Date: April 12, 2018

From: Midcoast Community Council/ Dave Olson, Chair

Subject: **Proposed 50-space RV Park on vacant 3.3 acres at NW corner  
Capistrano & Highway 1 in Princeton – PLN2017-00320 – APN-047-081-430**

Landscape Plan  
SCALE: 1" = 20'-0"

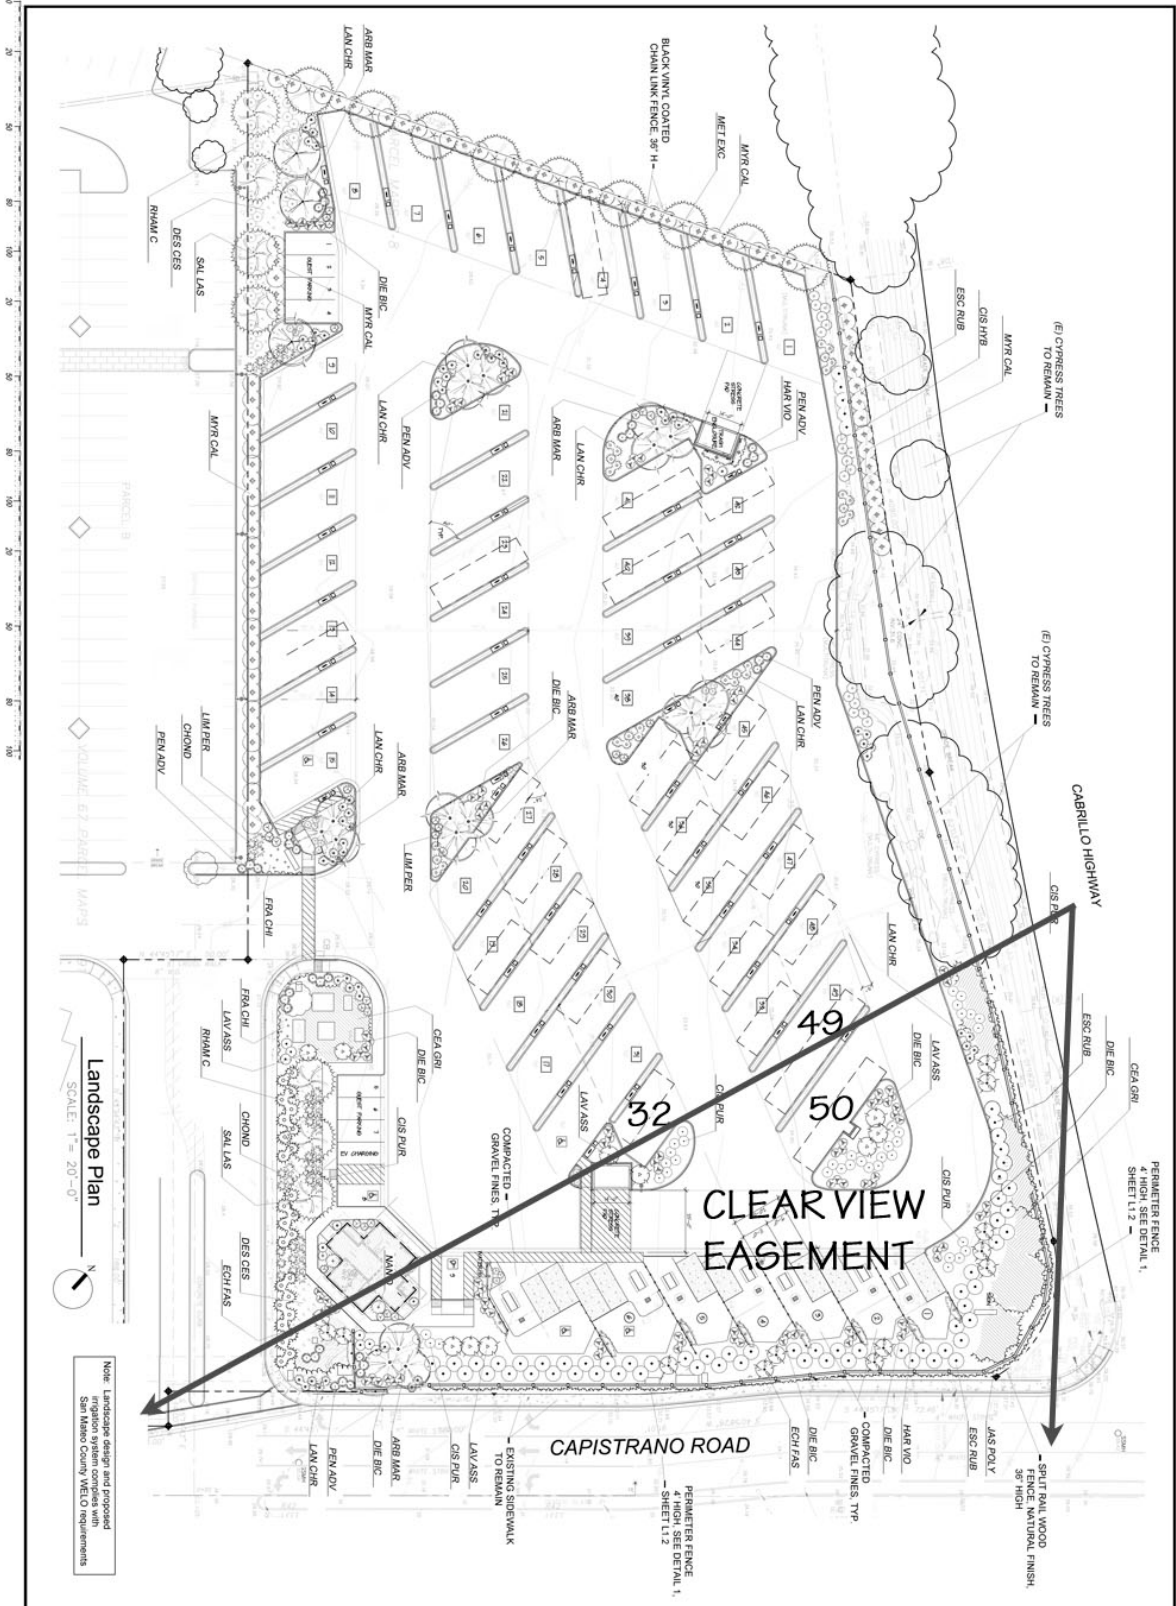
In order to preserve the existing view corridor, MCC requests a height-restricted Clear View Easement Area as shown on the attached site plan. All plantings within this area shall be no greater in height at maturity than 3 feet above the adjacent Capistrano Rd. elevation.

This perimeter fence has conflicting descriptions on the landscape plan. The 3-ft split rail fence is much preferred for style and transparency over the 4-ft post/wire mesh packed with vines. Please broaden the curve of the perimeter fence at the highway corner and pull it inside the sign, providing informal native plantings outside the fence in the public view.

The corner sign at Hwy 1 should be drastically reduced in size. It blocks the ocean view and is out of scale with its location. Some of the contents are redundant with the Harbor Village entrance sign (Sweetport, Caffè Mezzaluna, Lamas) and some are potentially illegal off-site advertising in the highway scenic corridor (Mezzaluna, HMB Brewing Co, Oceano Inn). All that is needed here is Oceano Hotel & Spa and Harbor Village Shoppes & RV Park (delete misnomer Half Moon Bay Harbor).

RV spaces are tight at 20 ft wide. CA HCD requires minimum 6-ft space between RVs. Interior rows show ~2-ft space between RVs in places, per dashed lines on plan.

Landscaping tall enough to screen the RVs from northbound Hwy 1 and Capistrano Rd needs to be planted north and outside of the Clear View Easement, which will require some modification of the RV layout plan. At a minimum this could be provided by removing space 32, 49 & 50 (south ends of inner rows) and devoting the full width of the rows at space 32 & 49 to tall landscaping backed by 10-ft lattice fence.

The landscape palette is heavily reliant on exotic species and quite similar to the adjacent hotel grounds under same ownership, where certain invasive species have been allowed to proliferate, while other plants have unfortunately declined, disappeared to bare dirt, or been pruned into unnatural shapes. The RV parking lot will greatly enlarge the vast unbroken expanse of Harbor Village parking lot, which sorely lacks visual interest that should be provided by extensive use of landscaping.
